**SITE:** Land west of Garbrook, Little Tarrington, Hereford, HR1 4JA  
**TYPE:** Outline  
**DESCRIPTION:** Proposed development of ten dwellings including 2 affordable homes and 2 self build plots and associated access road, footpath link, sustainable drainage, hedgerow, tree and orchard planting.  
**APPLICATION NO:** 184506  
**GRID REFERENCE:** OS 362478, 240838  
**APPLICANT:** Mr & Mrs Stock  
**AGENT:** Mr Russel Pryce

Figure 1: Environment Agency Flood Map for Planning (Rivers and Sea), January 2019

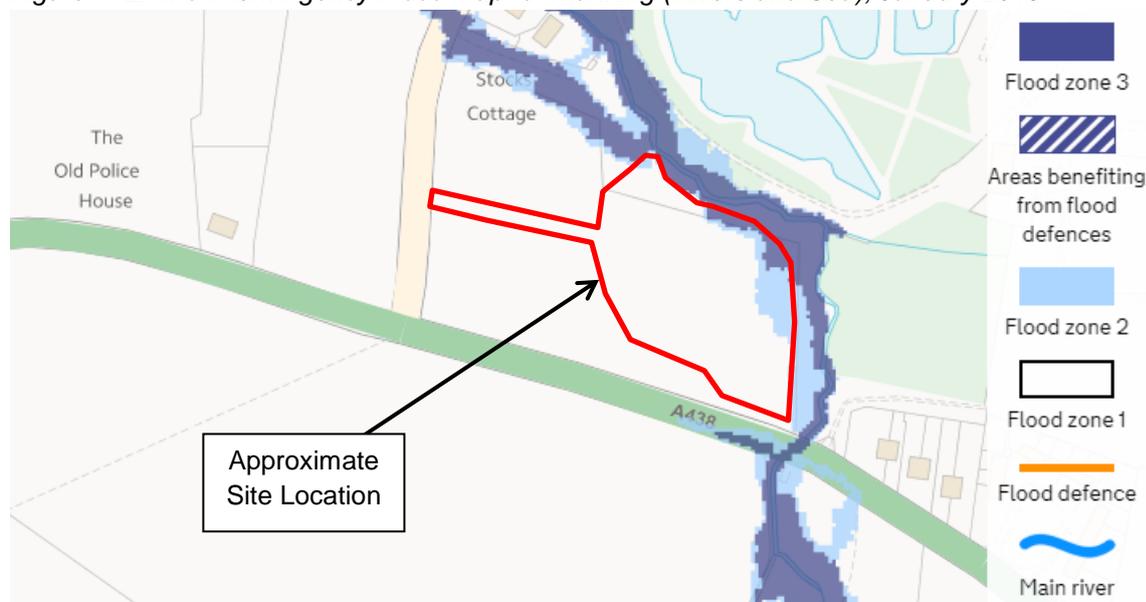
Review of the Environment Agency's Flood Map for Planning (Figure 1) indicates that the site is predominantly located within the low risk Flood Zone 1. However, the northern and eastern boundaries of the site are shown to be located in the high risk Flood Zones 3 and medium risk Flood Zone 2 associated with the adjacent ordinary watercourse. Flood Zone 1 comprises land assessed as having less than a 1 in 1,000 annual probability of river flooding; Flood Zone 2 comprises land

The Gar Brook discharges to the River Frome located approximately 1.7km to the north-west of the site. High water levels within the River Frome may cause water in the Gar Brook to back up and lead to localised flooding. The EA's Flood Map for Planning also indicates that the culvert beneath the railway to the north of the site may restrict the flow of flood waters.
